ADDENDUM 4.2-B
CLASS I DEEP DISPOSAL
WELL FIELD APPLICATION
CORRESPONDENCE

RE: Strata Energy, Inc. – Ross Disposal Injection Wells
Draft Permit **10-263**, Class I Non-hazardous Injection Wells
Crook County, Wyoming

PROJECT: Application 10-263
Strata Energy, Inc: Ross Disposal Injection Wells

TITLE: "UIC Permit Application Class I Injection Wells Ross Disposal Wells, Crook County,
Wyoming Strata Energy, Inc."

Table 5
Calculated NaCl Concentrations in Select Zones of the Minnelusa to Flathead Formation

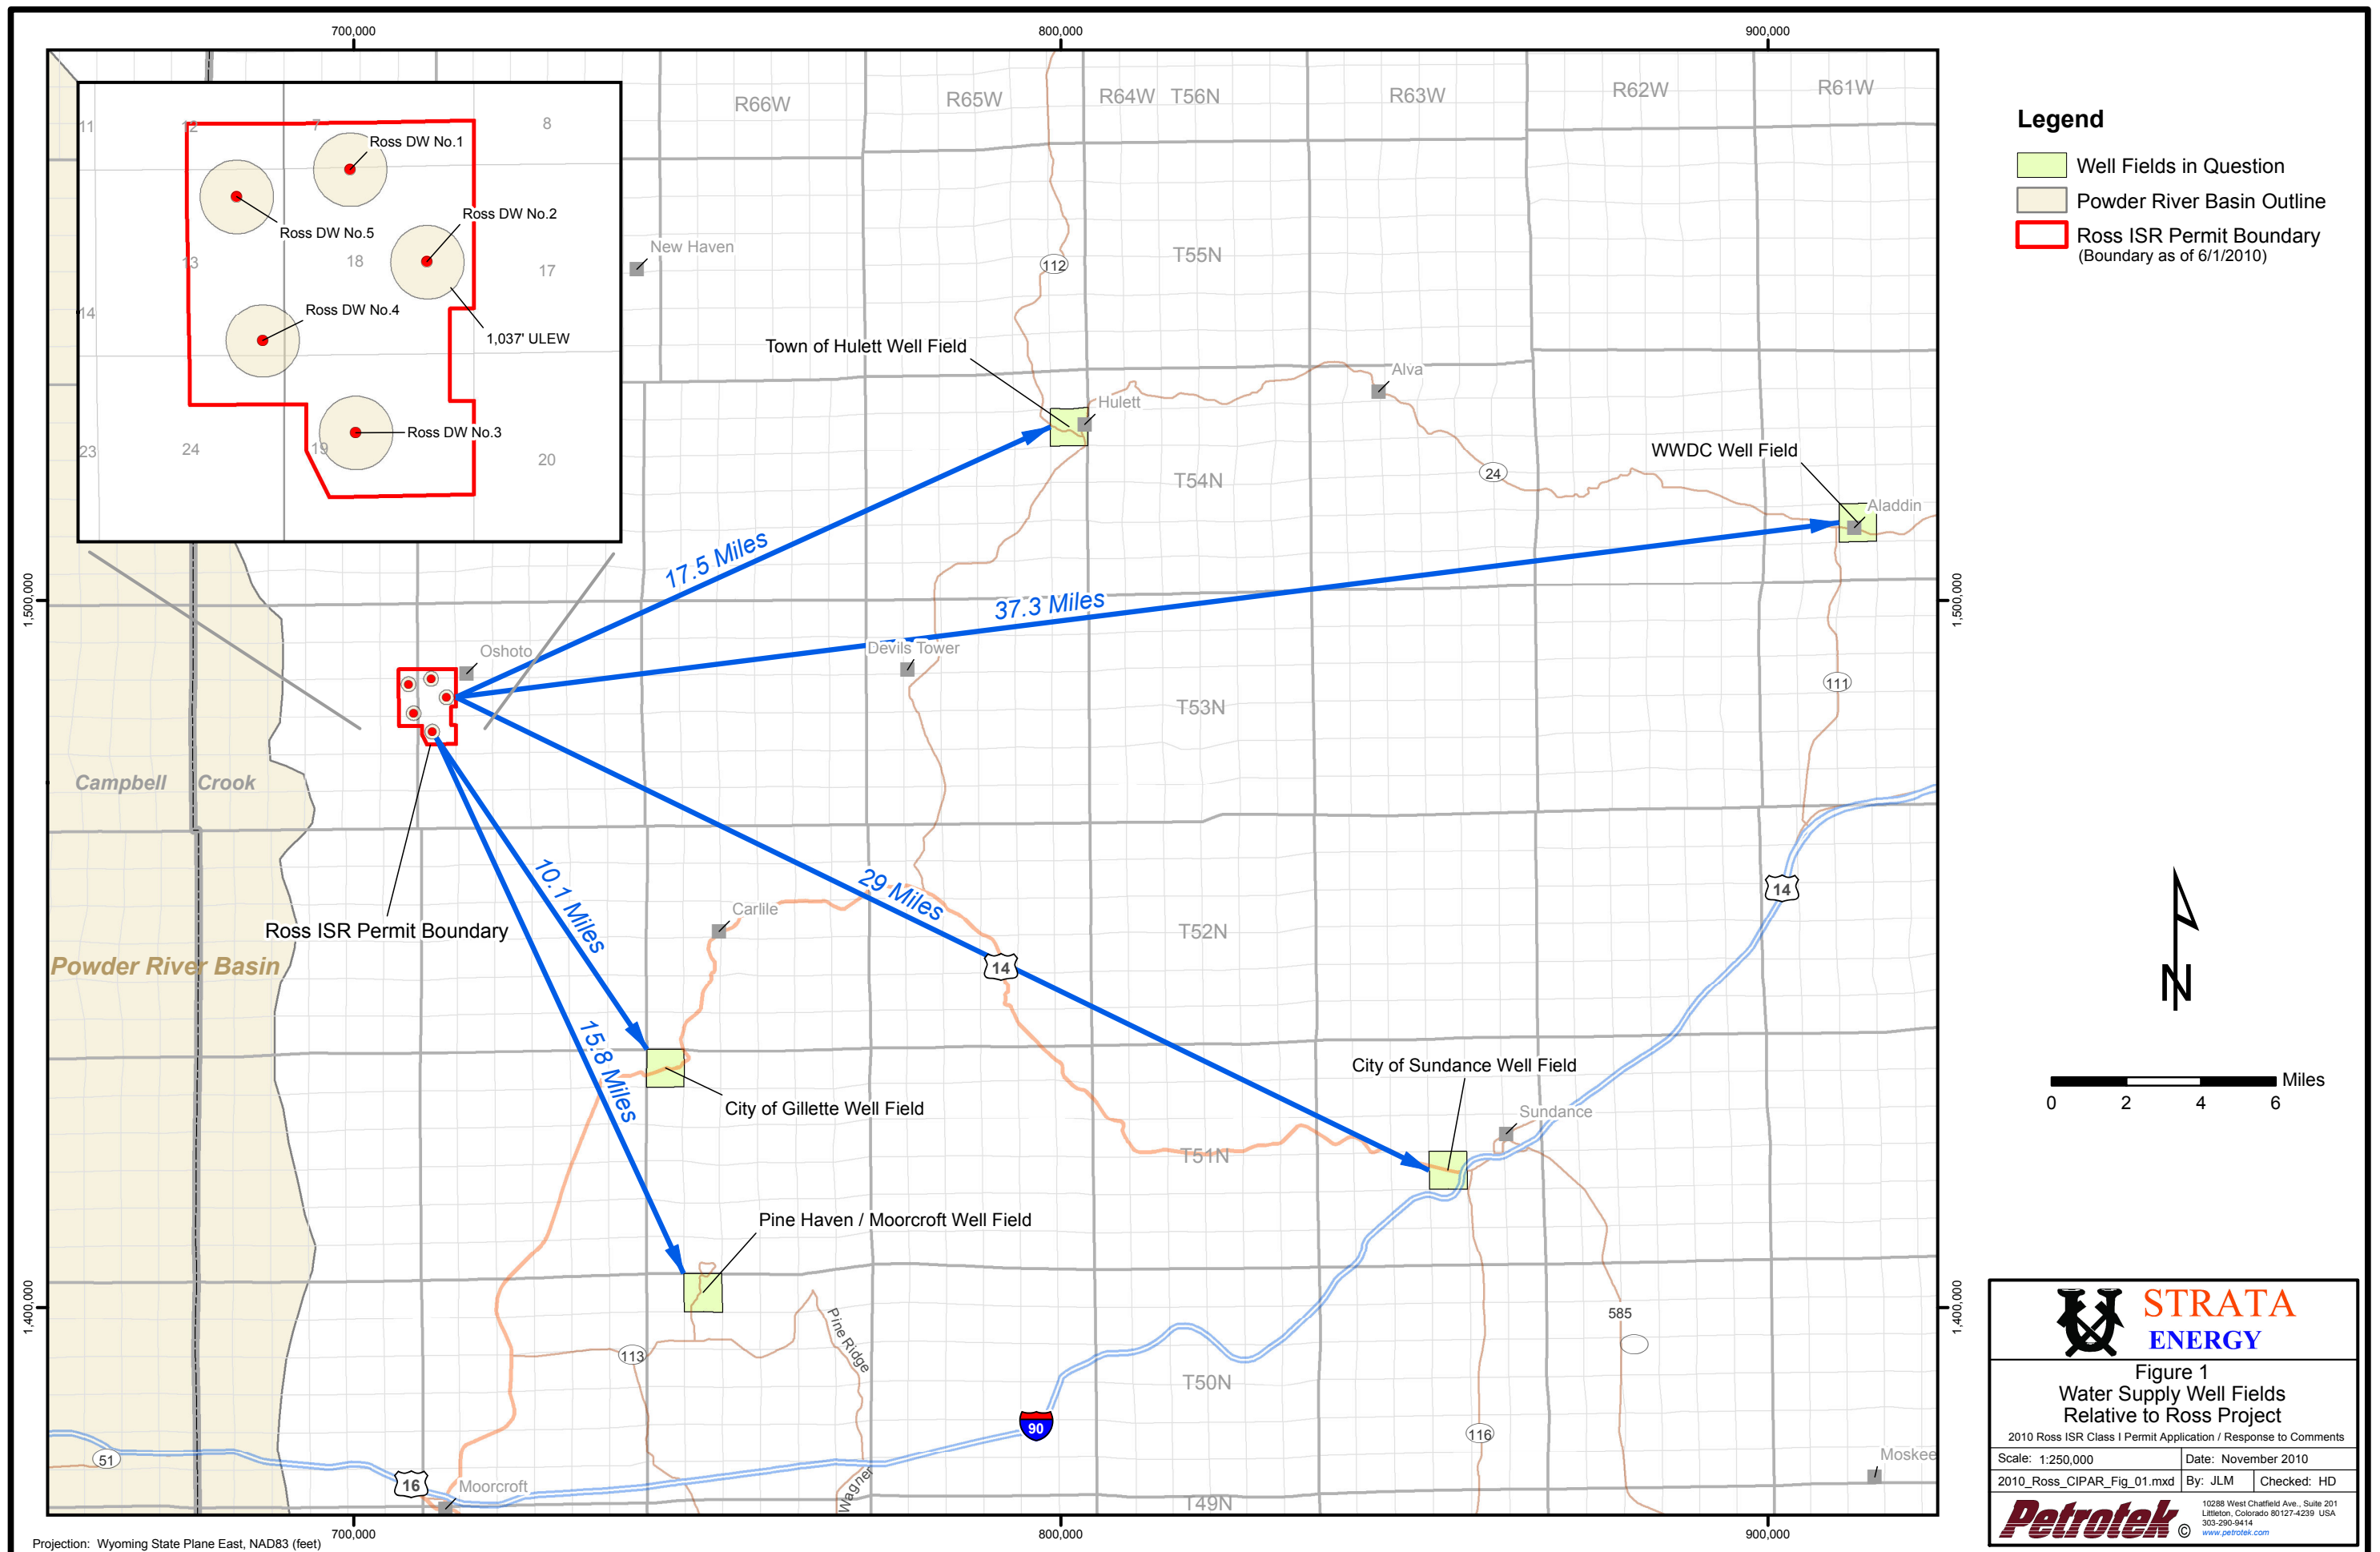
2. Please provide an Area of Review calculation using the 9 lb mud method as described in previous ISR permit applications.
3. Please explain why a BHT of 154 F was used for calculating K, when Table 5 of the report indicates a BHT of 121 F-128 F is more appropriate for the injected formations. Please revise K and AOR calculations accordingly.

3. Please explain why a BHT of 154 F was used for calculating K, when Table 5 of the report indicates a BHT of 121 F-128 F is more appropriate for the injected formations. Please revise K and AOR calculations accordingly.

Table 5 in the application includes information from four different wells with depths ranging from 4,111 to 11,000 feet and measured bottom hole temperatures (BHT) ranging from 119 F to 166 F. The temperature range of 121 F to 128 F referenced in the comment for the proposed injection zone refers only to the extrapolated conditions in the Madison Test Well #1 in Table 5 of the application.

Attachment 1 of this document is a revised Table 5. Strata requests that it replace the original in the application as typographical errors were noted while reviewing the original Table 5 for this response. Note that these typographical errors were the result of misplaced data but had no effect on the calculations presented for the proposed injection zone.
